Product Change Notice (PCN)

PCN Number: **PCN-0456165R**

Product(s) Affected: **PJ-036DH**

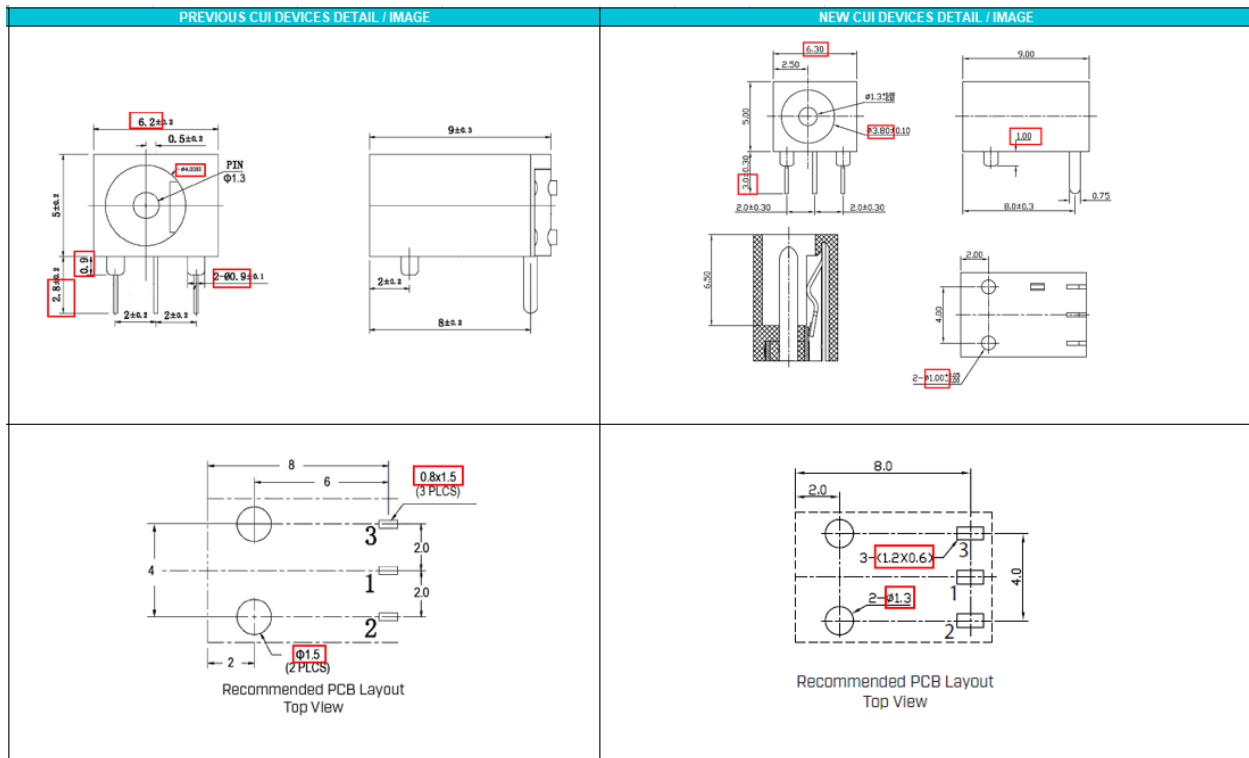
Description of Change: **New Factory Location. Product re-engineered for improved manufacturability and production yield. See image below for reference and check CUI Devices website for updated drawing. Cosmetic differences may be visible and not affect the form fit and function of the product.**

PREVIOUS CUI DEVICES DETAIL / IMAGE			NEW CUI DEVICES DETAIL / IMAGE		
DESCRIPTION	MATERIAL	PLATING/COLOR	DESCRIPTION	MATERIAL	PLATING/COLOR
center pin	brass	silver	center pin	brass	silver
terminal 1	brass t=0.25	silver	terminal 1	brass t=0.25	silver
terminal 2	brass t=0.25	silver	terminal 2	SUS301 t=0.25	silver
terminal 3	brass t=0.25	silver	terminal 3	brass t=0.25	silver
housing	PBT (UL94V-0)	black	housing	PPA (UL94V-0)	black

MATING PLUG
Jack Insertion Depth: 6.4 mm

MATING PLUG
Jack Insertion Depth: 6.5 mm
